Re: Petition 1286: West Brookfield Reliability Project
Development and Management Plan Amendment

Drainage Feature Modifications

WEST BROOKFIELD 14H
STORMWATER & EROSION CONTROL DETAILS
CIVIL PLAN & DETAILS
BROOKFIELD, CT

A handwritten signature in blue ink, appearing to read "Kathleen Shanley". The signature is fluid and cursive, with a large loop at the end.

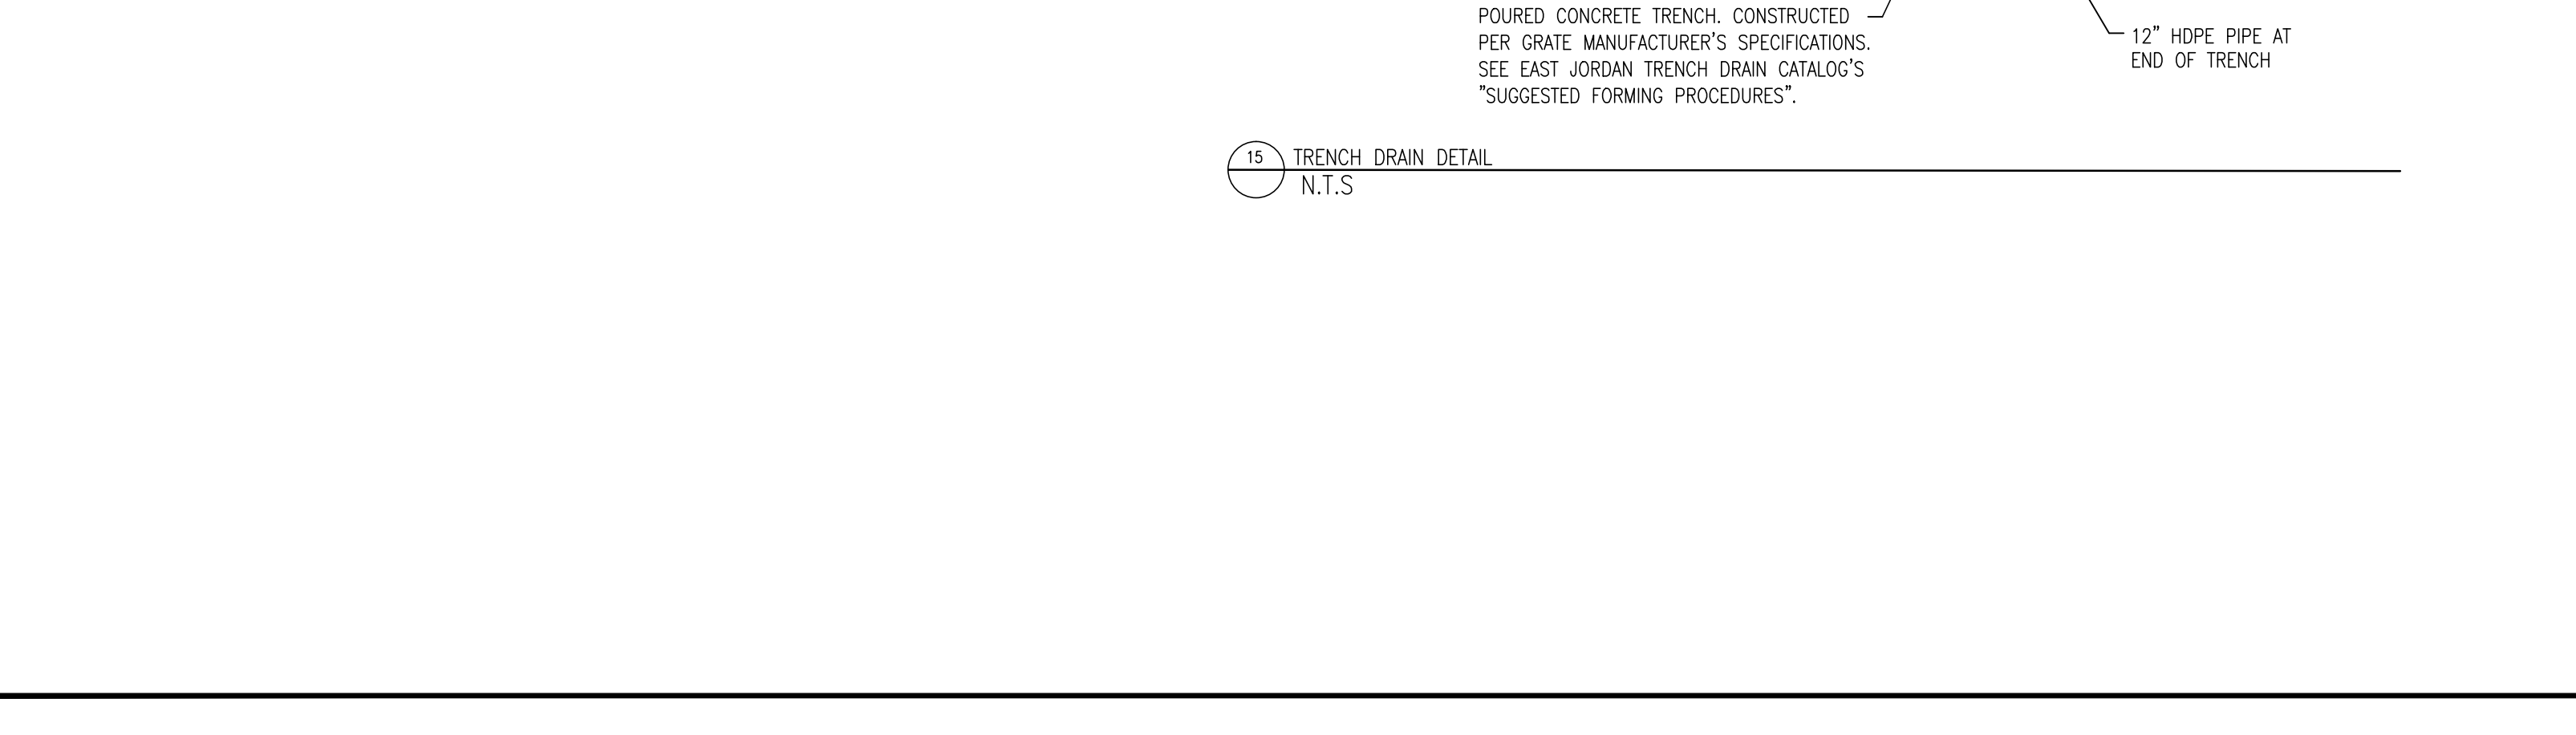
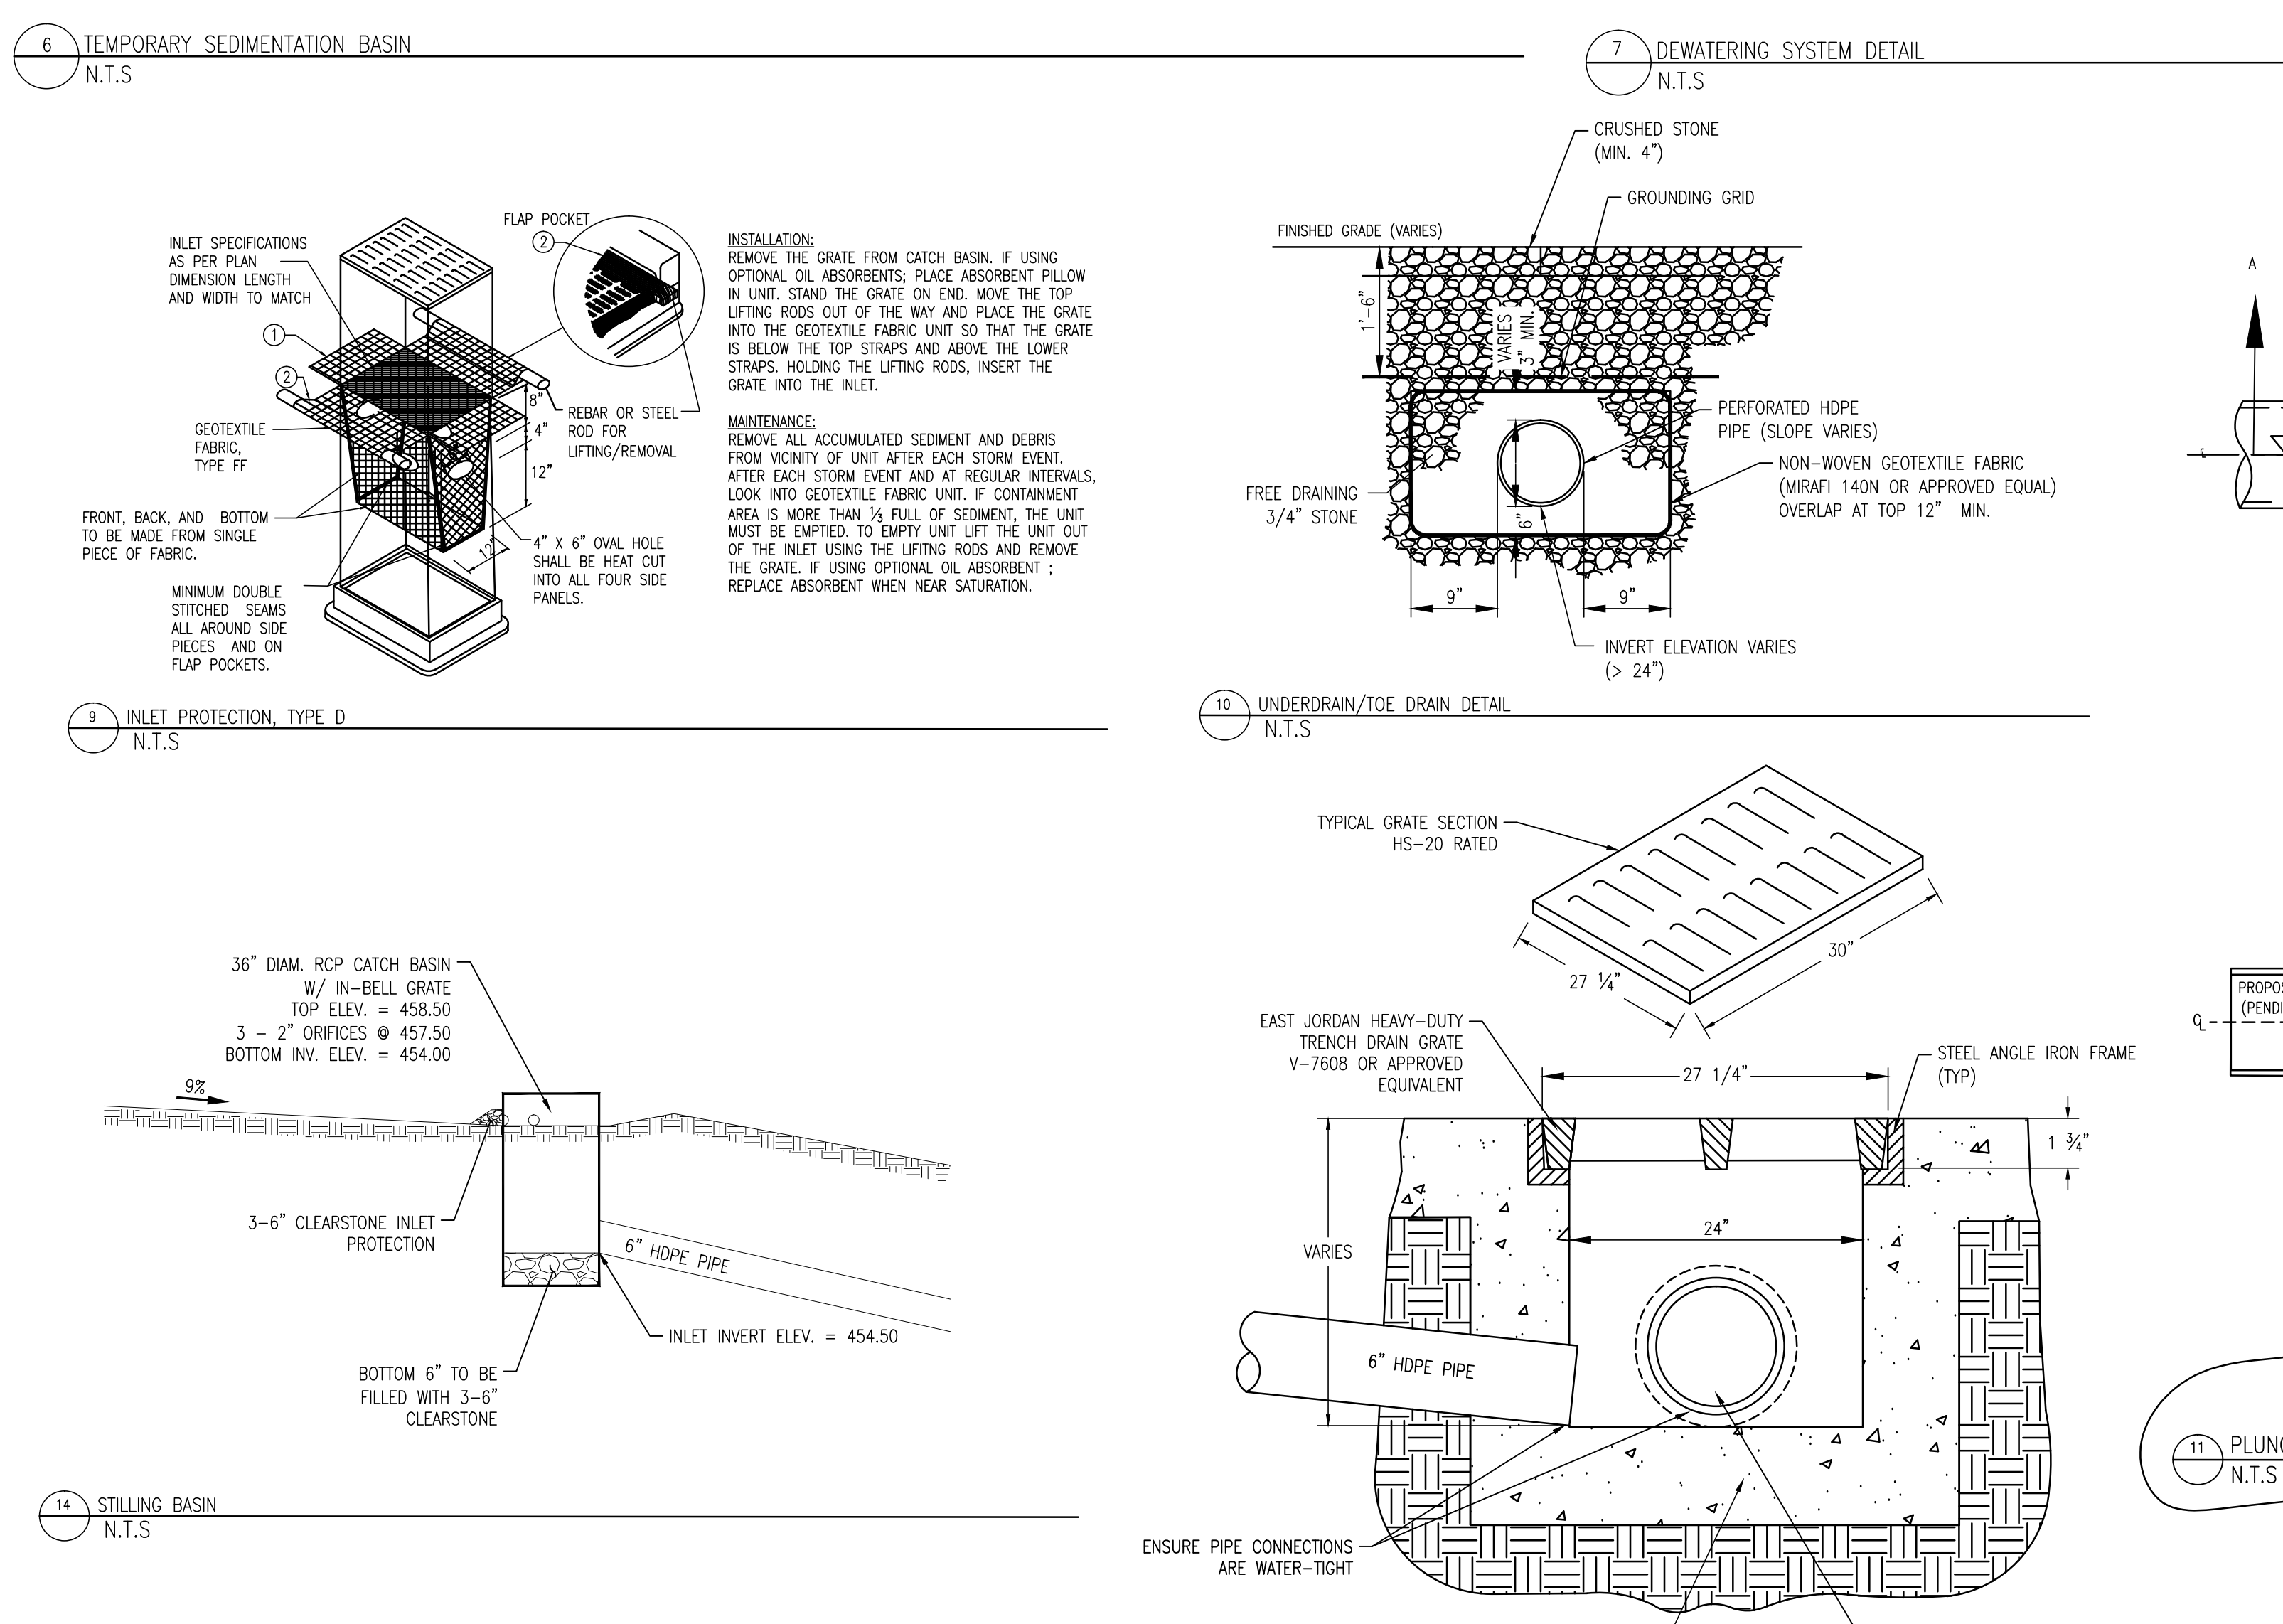
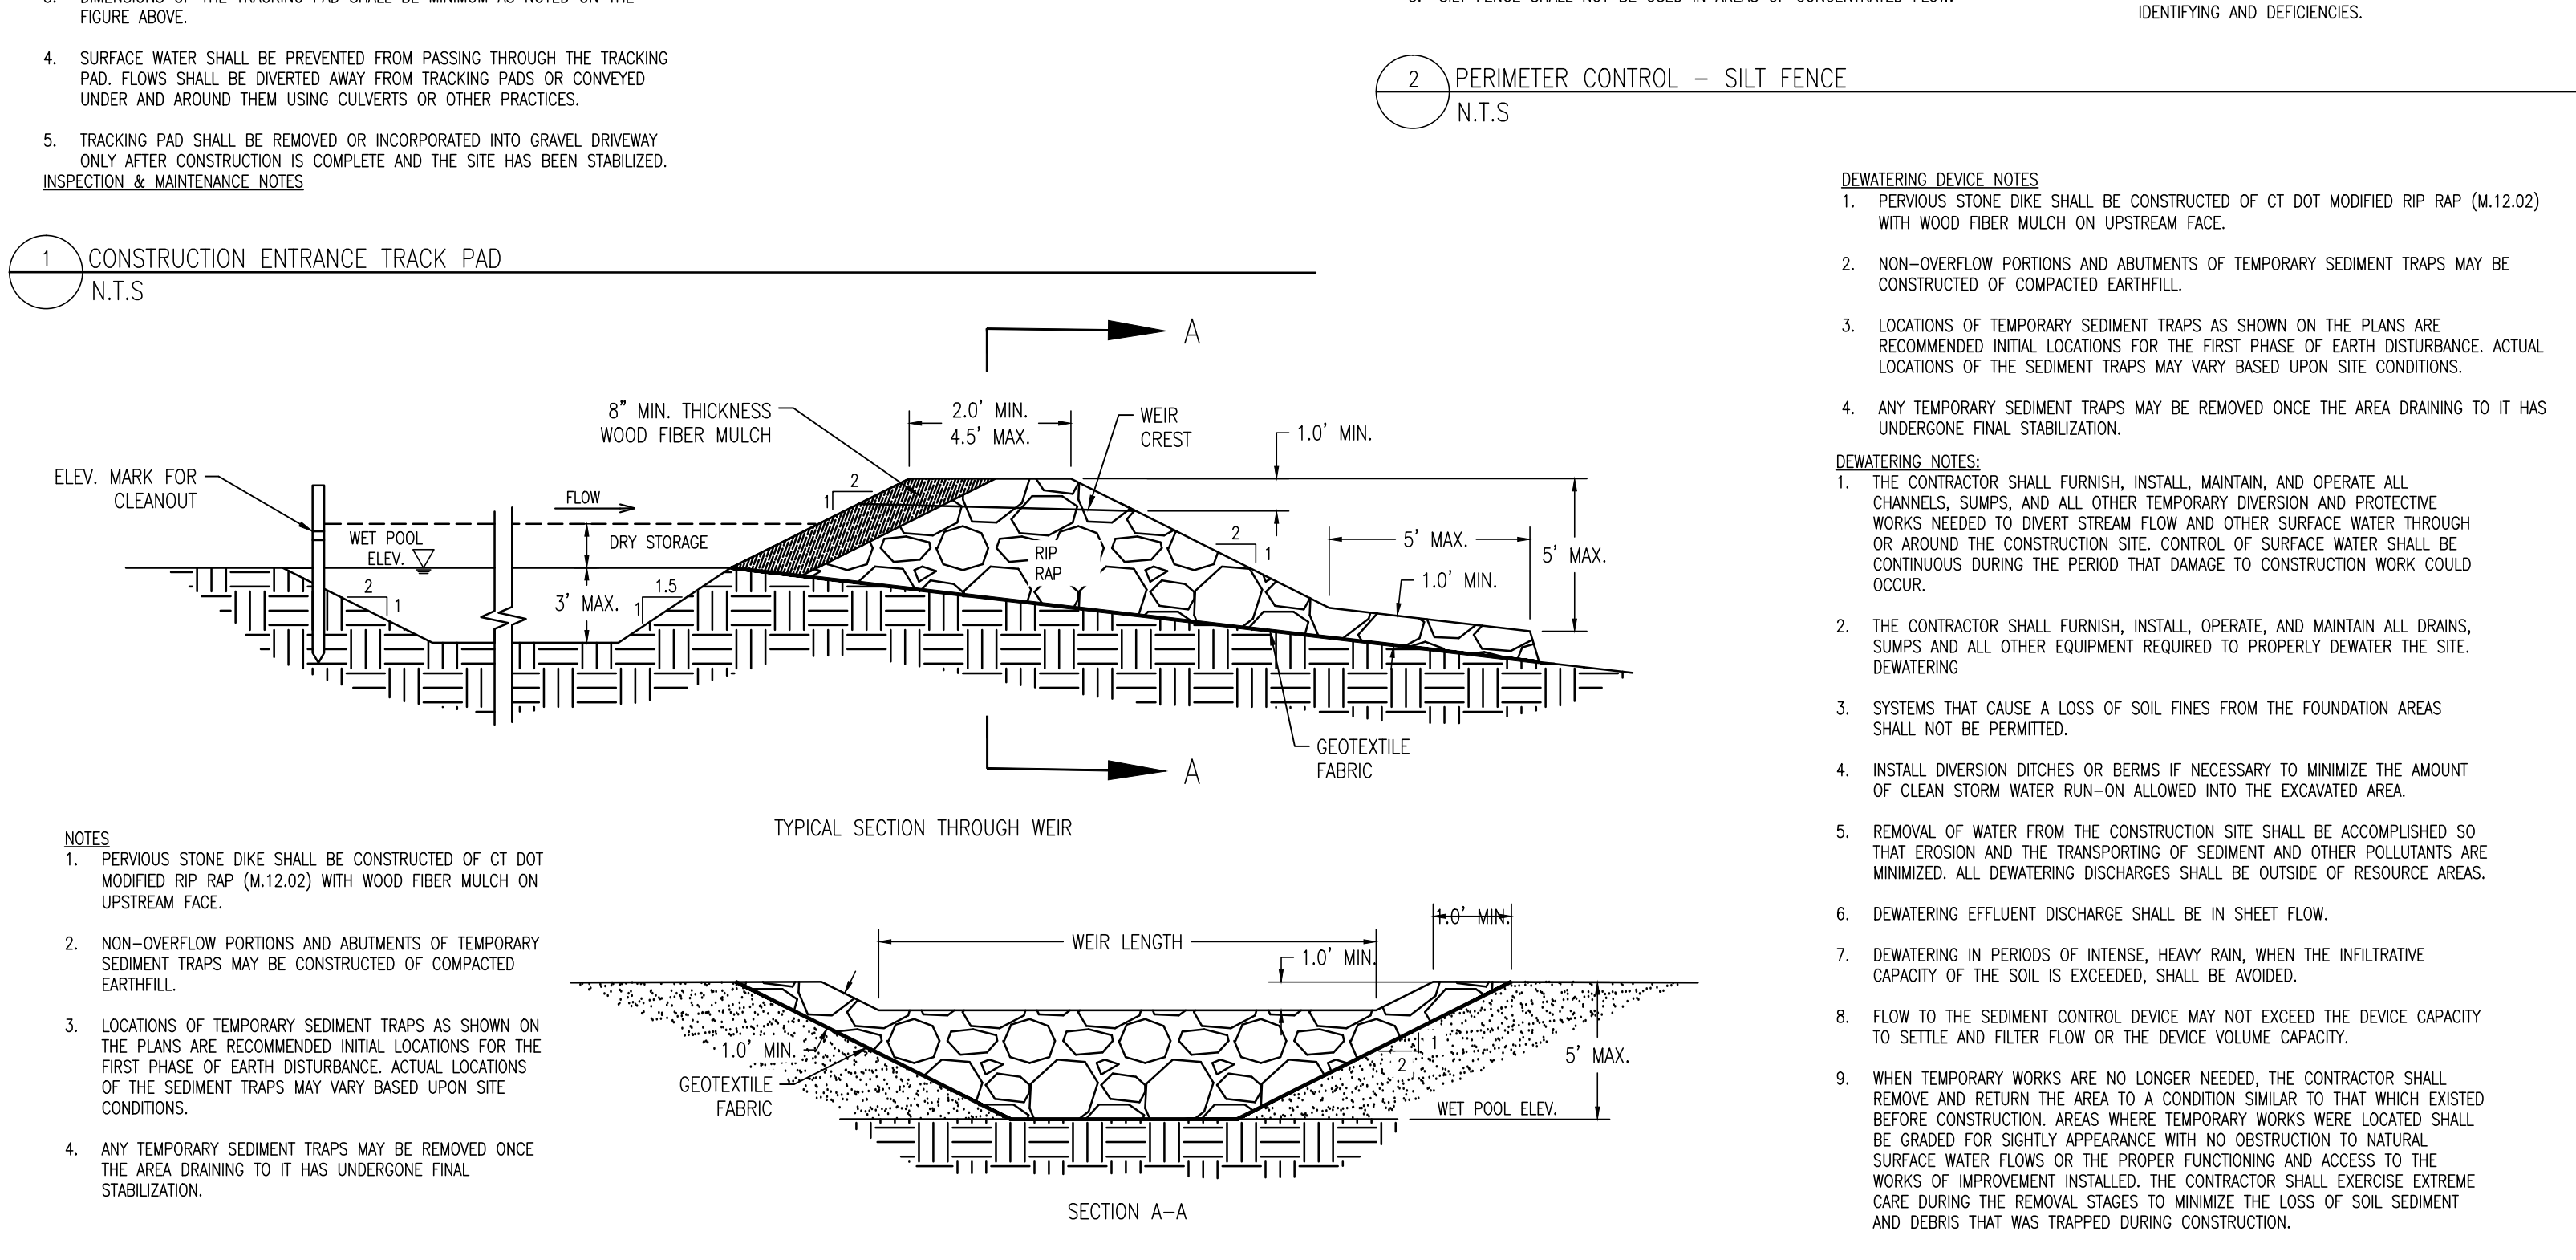
Subsequent to the Council’s approval of the D&M Plan, Eversource’s continued discussions with the property owner located to the west of the expanded substation. As a result, the abutter expressed a preference for plantings on their own property and agreed that this accommodation negated the need for additional plantings on the substation property that were intended to act as a buffer between the substation facility and this property owner (the approved plantings are identified as those with red clouds around them on the attached Visual Mitigation Landscape Planning plan). Eversource now proposes that the approved landscaping plan be modified to limit the plantings on Eversource property to the southwest corner of the entrance to the substation, which will be installed as proposed.

**DELETIONS FROM LANDSCAPE PLANTING PLAN**
